Bulletin No.: 14574
Date: April 2015

PRODUCT SAFETY RECALL

SUBJECT: Engine Oil Leak on Exhaust Manifold

MODELS: 2004 Buick Regal
2004 Chevrolet Impala
2004 Chevrolet Monte Carlo
Equipped with a 3.8L V6 engine (L36 or L67)

2257354

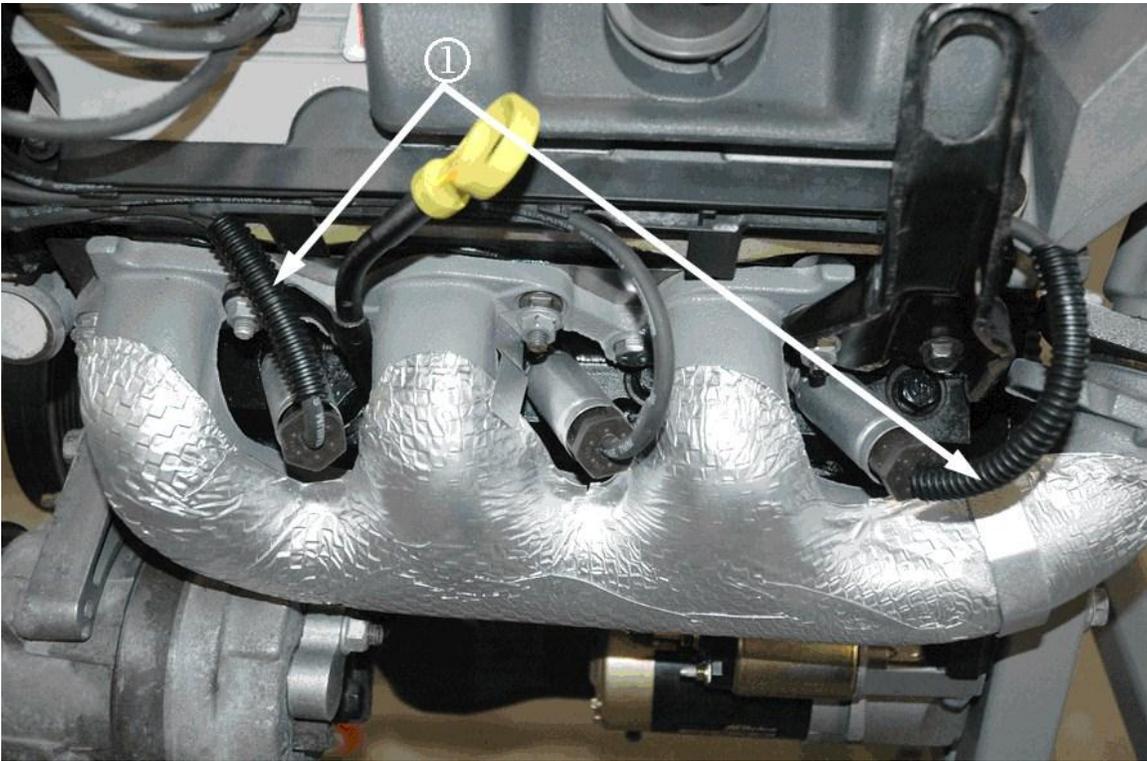
2. Remove the 1-3-5 spark plug plastic retaining channel (cover) clip/bracket (2) from the engine and discard it.

7mm Four-Wire Retainer, P/N 88891792

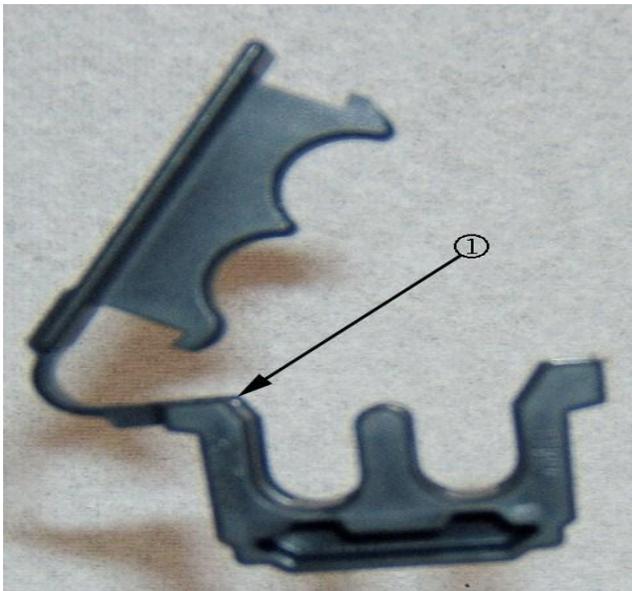
Note: If a 7m m four-wire retainer is not available, use an 8m m four-wire retainer (1), P/N 14066248 (Qty 10/pack), or equivalent 7m m aftermarket spark plug wire retainer.

4. Install a 7mm four-wire retainer, P/N 88891792 (1) (Qty 5/pack) to spark plug wire number 4, then to spark plug wires 1,3 and 5. Save the other 7mm or 8mm spark plug four-wire retainers for future repairs. Make sure that spark plug wires 2, 4 and 6 are secured to the original retainers and under the left engine mount strut bracket (2).

2257363

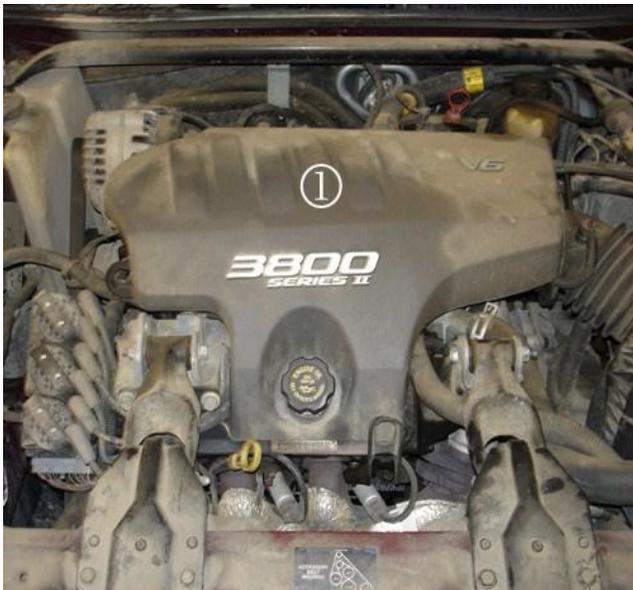
Note: Ensure that spark plug wires 3 and 5 are routed behind the oil level indicator and lift bracket. Ensure that the two-wire retainer (3), P/N 12132229, is positioned above the 3 spark plug wire boot. Do NOT position the retainer (3) above an exhaust runner.

5. Install a 7mm two-wire retainer, P/N 12132229 (Qty 10/pack) to spark plug wires 3 and 5 only (3). Save the other 7mm spark plug two-wire retainers for future repairs. Make sure the spark plug retainer (3) is approximately 50mm (2 in) from the oil level indicator (2).

7mm Four-Wire Retainer P/N 88891792

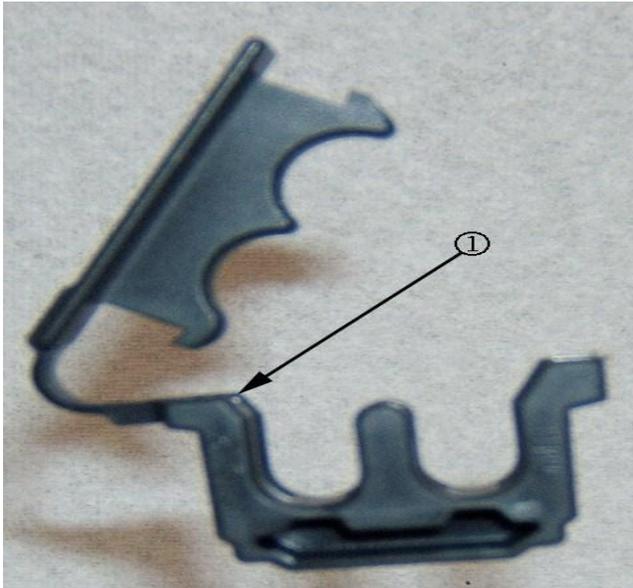
14. Install a 7 mm four-wire retainer, P/N 88891792 (1) (Qty 5/pack) to spark plug wire number 4, then to spark plug wires 1, 3 and 5. If not available, use 8 mm spark plug four-wire retainer (1), P/N 14066248 (Qty 10/pack), or equivalent 7mm aftermarket spark plug wire retainer. Save the other 7 mm or 8 mm spark plug four-wire retainers for future repairs.

2077730

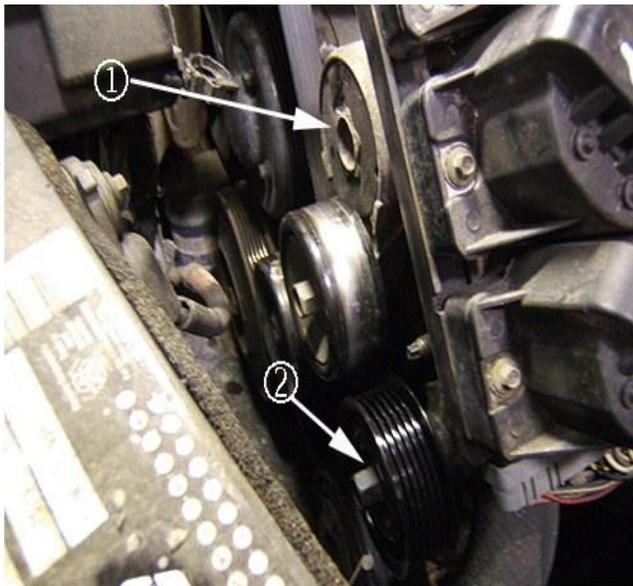
- 14.2. Install the 7 mm four-wire retainer, P/N 88891792 to spark plug wire number 4 (1) then to spark plug wires 1, 3 and 5 (2). Make sure that spark plug wires 2, 4 and 6 are secured to the original retainers and under the left engine mount strut bracket.
